**TOWN OF PORTOLA VALLEY
ARCHITECTURAL AND SITE CONTROL COMMISSION (ASCC)
Monday, November 12, 2012
Special Field Meeting (time and place as listed herein)
7:30 PM – Regular ASCC Meeting
Historic Schoolhouse
765 Portola Road, Portola Valley, CA 94028**

MEMORANDUM

TO: ASCC
FROM: Tom Vlastic, Town Planner
DATE: November 8, 2012
RE: Agenda for November 12, 2012 ASCC Meeting

SITE PLAN — REVISED STITCH PIER LOCATIONS		
DATE: October 2012	SCALE: 1" = 20'	JOB NO: MOHSE-01-01
		PLATE: 1

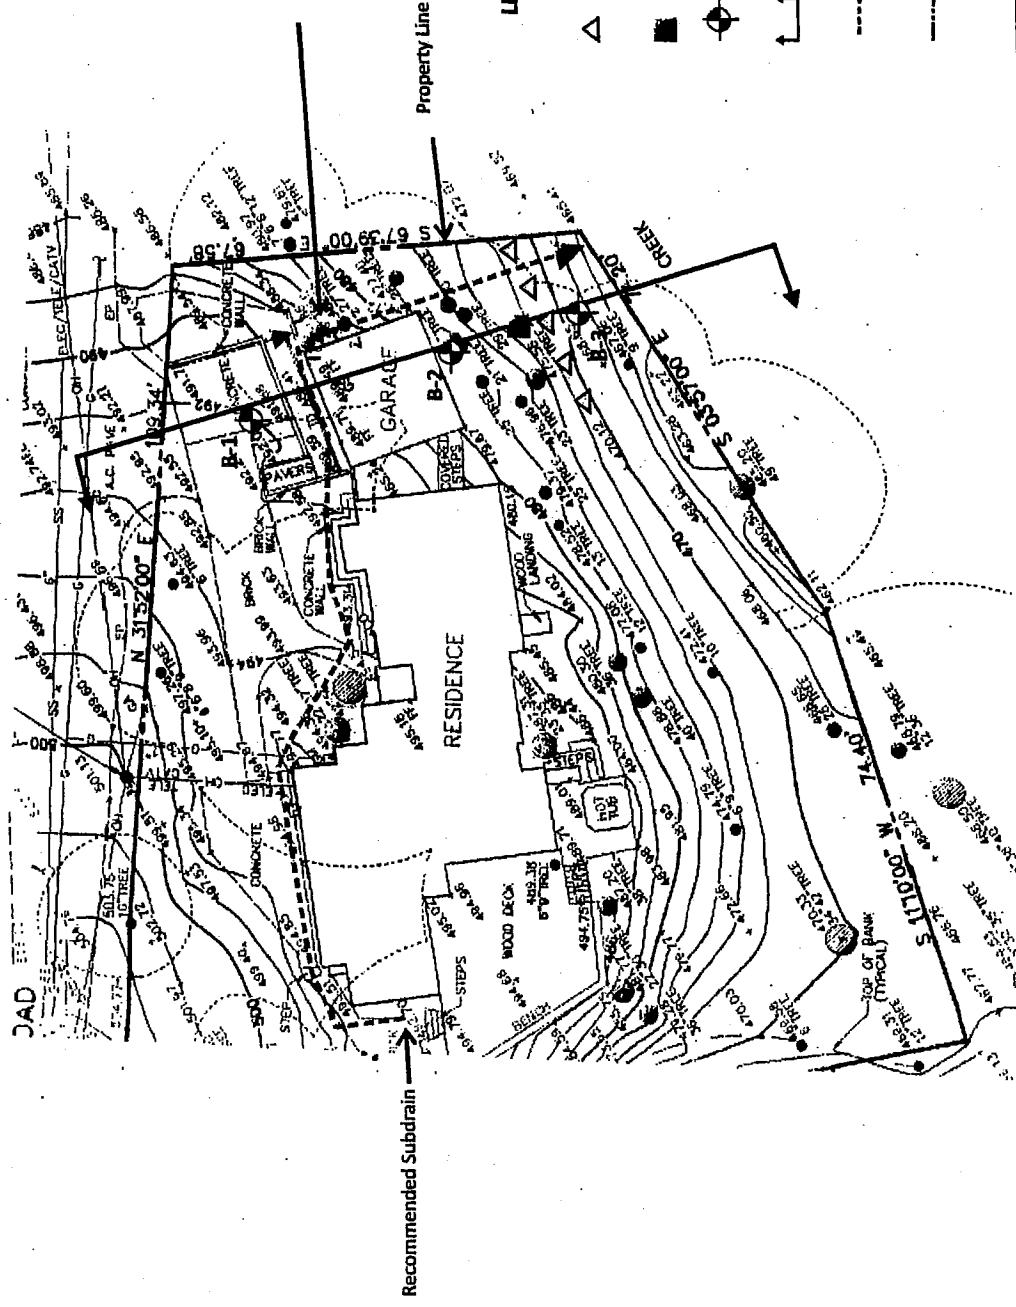
2. **Consideration of moving the stitch pier row upslope of the redwood trees to minimize construction impacts.** The plans have been modified to move the location of the proposed stitch piers uphill as explained in the attached October 16, 2012 letter from BAGG Engineering. The town geologist has advised that he has no issue with the adjustments subject to his review of final details for construction staging. The BAGG letter, however, does set forth directions for drill rig location and also notes that some minor field adjustments may be needed to ensure piers are located to minimize potential tree impacts. The site map with the BAGG letter and the revised site plans show the new proposal for pier locations.

The new pier locations, as shown on the attached Plate 1, Site Plan – Revised Stitch Pier Locations, have now been staggered to avoid the existing trees. The attached site plan also

SITE PLAN — PROPOSED STITCH PIERS

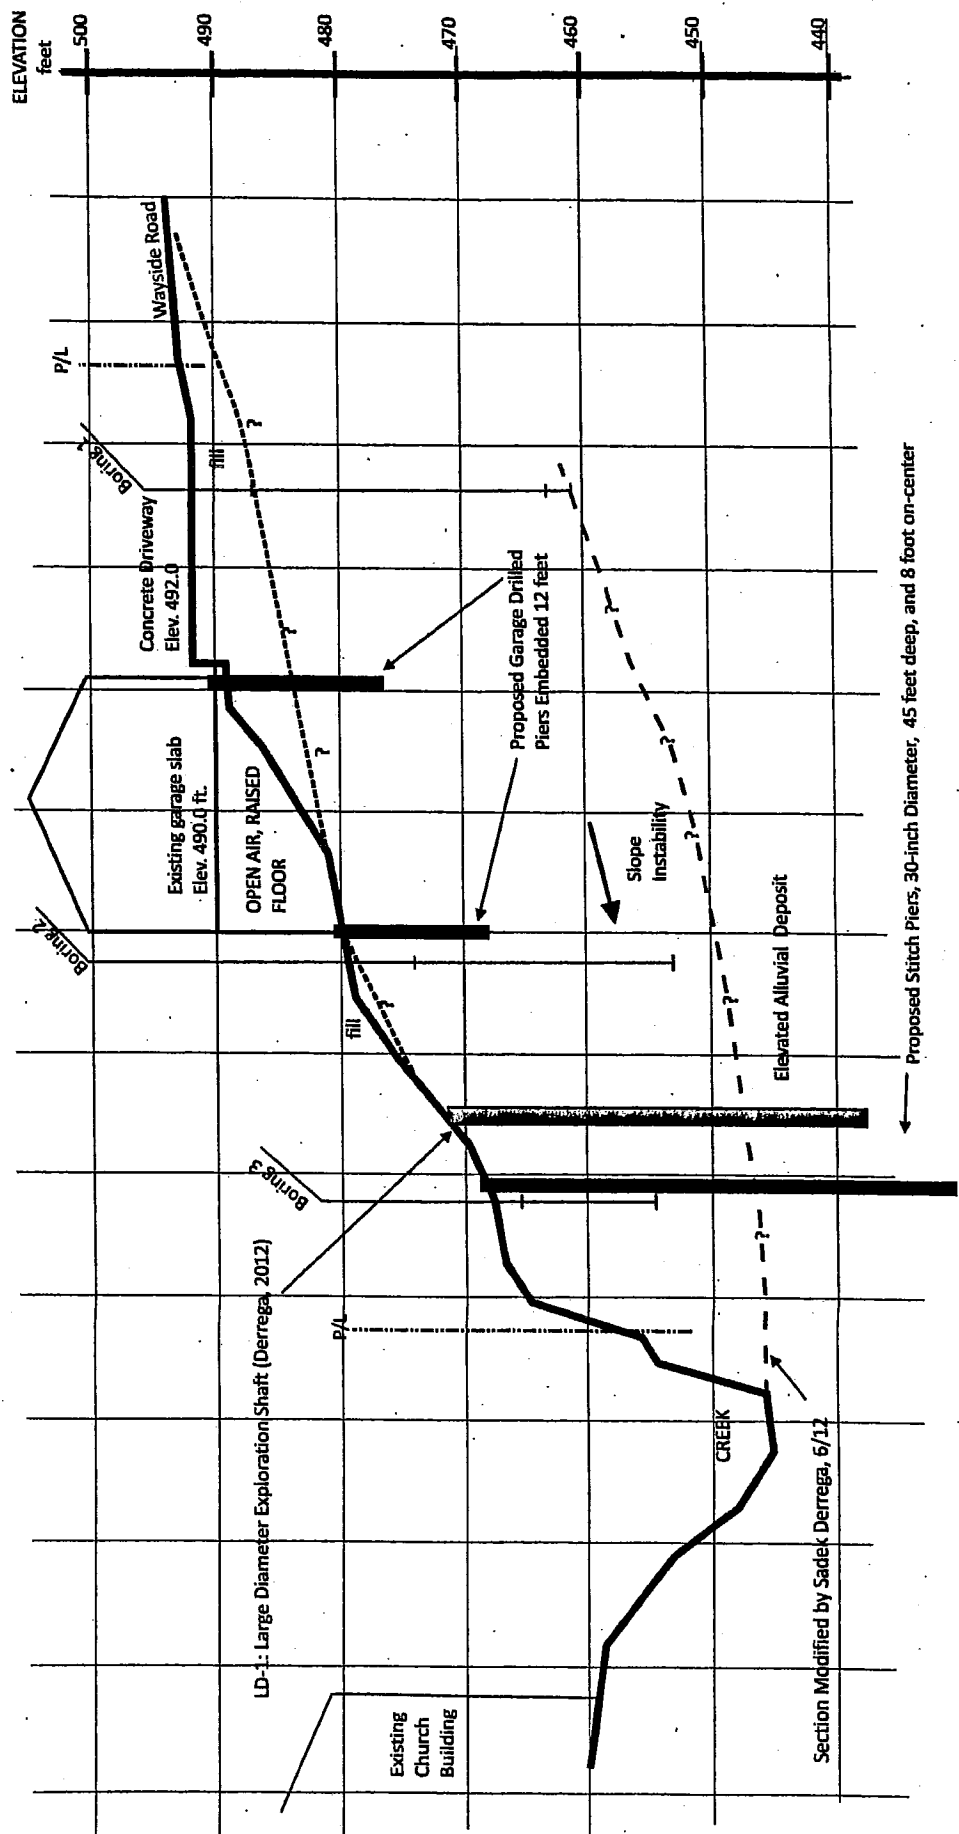
Concern was also expressed over the need for a detailed construction-staging plan to ensure that the work on the slope stabilization would not cause additional problems. Warr suggested that consideration be given, if possible, to locating the line of stitch piers up slope, perhaps closer to the garage, to make the construction process easier and, hopefully, avoid impacts on the larger redwood trees downslope of the garage.
